Peter D Webb & Associates
Flood Study - Lot 4 Great Southern Highway, York

Schedule of Submissions

SHIRE OF YORK

AMENDMENT NO. 31

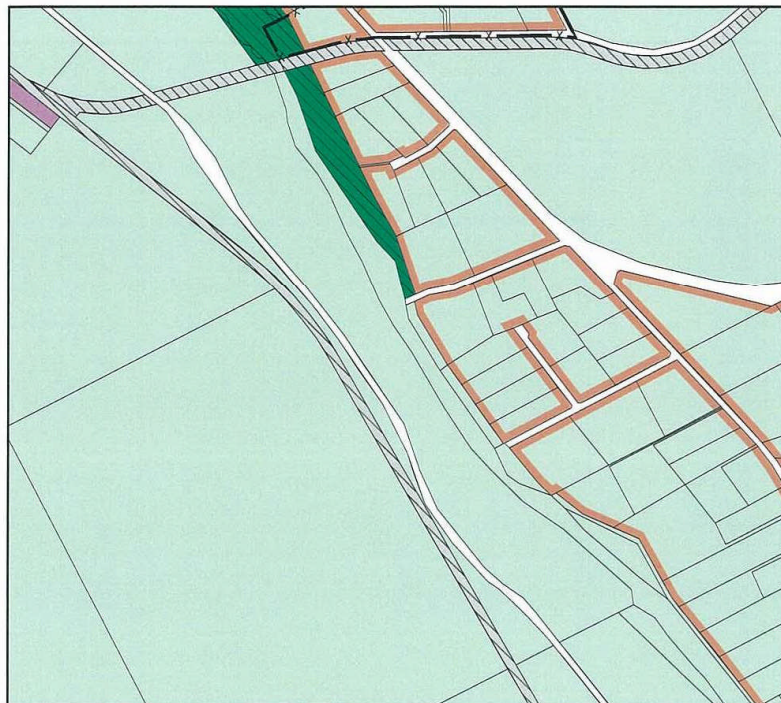
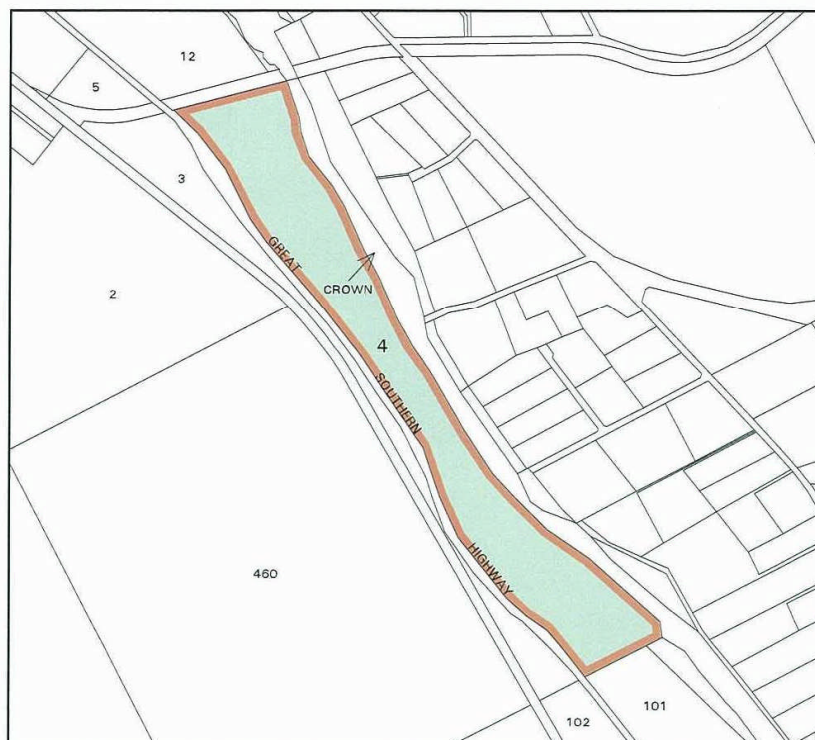
Submitter	Submission Received	Applicant's Comments	Officer's Comments
Water Corporation	The Corporation has no objections to the proposed rezoning, subject to building envelopes on the proposed lots shown on the Outline Development Plan being setback at least 500m from the edge of the wastewater treatment ponds at the York Waste Water Treatment Plant, in accordance with EPA Guideline Statement No. 3 (Separation Distances between Industrial and Sensitive Land Uses).	Noted. All proposed lots are provided with a designated building envelope which provides sufficient land for development outside of the 500m buffer around the wastewater treatment ponds. This buffer is illustrated on the ODP.	Noted. Building envelope to be confirmed on final ODP.
Department of Education	The Department of Education has reviewed the proposal for rezoning and advises that it has no objection to this Amendment.	Noted.	Noted.

Heritage Council	We note the place is adjacent to the Balladong Farm Group (Place No. 2867) which is listed in the State Register of Heritage Places. The development referral has been assessed in the context of the identified heritage significance of the Balladong Farm Group. We advise that the proposed rezoning of the property from 'General Agriculture' to 'Rural Residential' is not considered to have a negative impact and as such, we have no objection to the proposal.	Noted.	Noted.
Department of Mines and Petroleum	Geological Survey of Western Australia, a division of Department of Mines and Petroleum has briefly assessed the area for mineral potential and has no access concerns regarding mineral resources.	Noted.	Noted.
Department of Regional Development and Lands	As the land concerned is freehold, RDL has no comment to make.	Noted.	Noted.
Main Roads	Main Roads WA is not prepared to support a rezoning or subdivision at this location until such time as the location and alignment of future heavy haulage transport corridors are decided. The following have been identified as critical issues for Main Roads WA:	<ul style="list-style-type: none"> At the Ordinary Meeting of Council held on August 18, 2008, Amendment No. 31 was formally initiated. Prior to the Amendment being initiated, the ODP for the land was provided to all relevant government authorities for comment. Main Roads WA (MRWA) provided similar comments to those 	The proposal is consistent with the York Local Planning Strategy and issues raised during assessment of the proposal have been

<p>with access being restricted to service roads combined with shared accesses. The ODP proposes three controlled access points onto Great Southern Highway.</p> <ul style="list-style-type: none"> • Lots 1 to 5 are provided with a service road and one shared access onto Great Southern Highway. • Lots 6 and 7 are provided with a single shared access to the Highway. • Lots 8 to 10 share a single access point onto the Highway. <p>The ODP has been designed to satisfactorily address the matters raised by MRWA to enable the proposed Amendment to be adopted and sent to the Minister for Planning for final determination.</p>	
Department of Water	<p>Thank you for the opportunity to comment on this proposal which is situated adjacent o the Avon River. Several minor non-perennial watercourses flow in an easterly direction through the subject land.</p> <p>The Department of Water (DoW) has considered this proposal and provides the following comments for consideration:</p> <ul style="list-style-type: none"> • DoW requests the submission of a Local Water Management Strategy (LWMS) which contains the level of information that reflects the level of risk to water resources. The LWMS should be approved by the DoW prior to the finalisation of the local planning scheme amendment. Flood management issues, including relevant flood levels and mapping should be included. The impact of development on the downstream receiving environment also should be addressed, including the potential impact upon the Avon River. Flood storage areas should be developed outside the natural watercourse. • The proposal is located within a proclaimed surface water area. In accordance with the <i>Rights in Water and Irrigation Act 1914</i>, extraction of surface water for intensive activities 	<ul style="list-style-type: none"> • A detailed Land Capability Study prepared by Landform Research, further Environmental reporting provided by Land Assessment Pty Ltd and a recent Flood Study prepared by JDA Consultant Hydrologists for the land provides sufficient information regarding water resources together with flood levels and mapping. A Local Water Management Strategy is not considered necessary as part of the Amendment process, given the extensive environmental assessment and studies already undertaken which have already considered the level of impact of the proposed development on the environmental values of the Avon River and concluded that this site is more than capable of supporting residential development. It is considered more suitable that an Urban Water Management Plan be required to be lodged as part of the subsequent subdivision application. • Advice regarding the area being located within a proclaimed surface water area is noted. • DoW recommended floodplain development strategy is noted. These recommendations have been incorporated into the Amendment document. 	Agree with applicant's comments.

<p>including dust suppression may require a licence. Modification to a watercourse, its bed or banks requires a permit from the Department of Water.</p> <ul style="list-style-type: none">The Avon River Flood Study shows that Lot 4 Great Southern Highway in York is affected by flooding during major river flows with the flood levels estimated to be:

<p>Please note that the flood level of 172.12 AHD quoted in the amendment document is incorrect.</p> <ul style="list-style-type: none">DoW's recommended floodplain development strategy is outlined below:<ul style="list-style-type: none">Proposed development (ie filling, building, etc) that is located outside the floodway is considered acceptable with respect to major flooding. However, a minimum habitable flood level of 0.5 metre above the appropriate 100 year ARI flood level is recommended to ensure adequate flood protection.Lot specific comments are:<ul style="list-style-type: none">Lots 1-5 will experience floodwaters to a depth of 0.5m on access tracks, this should be taken into consideration when considering evacuation from the lots in the times of major river flooding.For the purposes of minimising isolation on lots 6 and 7, it is recommended that proposed dwellings are located on the western side of the lots.		Upstream boundary (south)	Downstream boundary (north)	10 year ARI	175.20m AHD	173.90m AHD	25 year ARI	175.90m AHD	174.70m AHD	100 year ARI	177.20m AHD	175.90m AHD	<ul style="list-style-type: none">The advice regarding harvesting water and the need to alert prospective purchasers to the requirements has been incorporated into the Amendment document.The Amendment document has been updated to include the additional information provided to the EPA and DoW, including the requirement for each lot to be serviced by ATUs.	
	Upstream boundary (south)	Downstream boundary (north)													
10 year ARI	175.20m AHD	173.90m AHD													
25 year ARI	175.90m AHD	174.70m AHD													
100 year ARI	177.20m AHD	175.90m AHD

<ul style="list-style-type: none"> ○ It is recommended that proposed dwellings on Lots 8 & 9 be located to the west of the drainage line that flows across the lots as dwellings to the east of this line will become seriously isolated during times of major flooding with floodwaters being approximately 1 metre deep. For Lot 10, it is recommended that a proposed dwelling is located on the western side of the lot (close to the Great Southern Highway). ○ Proposed development (ie, filling, building, etc) that is located within the floodway and is considered obstructive to major flows is not acceptable as it would increase flood levels upstream. No new buildings are acceptable in the floodway. ○ Please note that a failure to properly adhere to these recommendations will result in a greater exposure to risks of flood damage. It should be noted that this advice is related to major flooding only and other planning issues, such as environmental and ecological considerations, may also need to be addressed. ● The proposal suggests landholders will be self suppliers with respect to harvesting their own water. Prospective purchasers should be aware that, in an average rainfall year of 426mm, each individual in a household needs approximately 132 sq m of roof space (ie 528 sq m for 4 people) for harvesting of domestic water only (based upon 150 L/person/day, and 98% of rainfall harvested). This is before considerations are given for fire fighting, garden and stock water requirements. Note that the abovementioned roof space per capita is inadequate in below average rainfall years. This is based on the

<p>(2000) or Schedule 8 of the Health (Treatment of Sewage and Disposal of Effluent and Liquid Waste) Regulations 1974.</p> <p>Proposed lots No 6 and 7 do not appear to be outside the minimum buffer zone from the Eastern edge of the sewerage ponds, the Department of Health cannot support this proposal unless the minimum buffer distance to dwellings can be achieved or are deemed acceptable by the Department of Environment and Conservation.</p> <p>Lots 8 and 9 are split with water courses between which are not desirable as it increases the potential to develop on the smaller portions of the lot. It would be more desirable if these lots were modified.</p> <p>Until such time the geotechnical report is received and considered, this Department is not prepared to support the proposal.</p>	<p>approval.</p> <p>3. In response to the Department's comments regarding Lots 6 and 7, we advise that the 500m buffer zone of the sewerage ponds is illustrated on the ODP. The building envelope for Lot 7 is located entirely outside of the buffer zone. It is recognised that a small section of the western edge of the building envelope on Lot 6 is located within the buffer zone. However, the majority of the building envelope on Lot 6 is located outside of the buffer zone, with approximately 7422m² of land area being available for development outside of the buffer zone. It is therefore apparent that future dwellings on both of these lots are able to be developed to meet this minimum buffer distance requirement.</p> <p>4. In regard to the Department's comments regarding Lots 8 and 9, we advise that the ODP includes a notation (No. 5) which refers to the Department of Water recommendation for the dwellings on Lots 8 and 9 to be located to the west of the drainage line. The western portion of the building envelope on Lot 8 has a land area of 2934m²; and the western portion of building envelope on Lot 9 has an area of 1239m². Therefore, it is evident that there is more than sufficient land within the western portions of the building envelopes on these two lots for residential development.</p> <p>5. The Department has confirmed that the proposal meets the requirements for exemption from the mandatory sewer condition of the Country Sewerage Policy. The Amendment is supported by technical studies which confirm that this site is more than capable of being subdivided and developed as Rural Residential development. Any requirement for a geotechnical investigation is best undertaken as a condition of subdivision approval.</p>
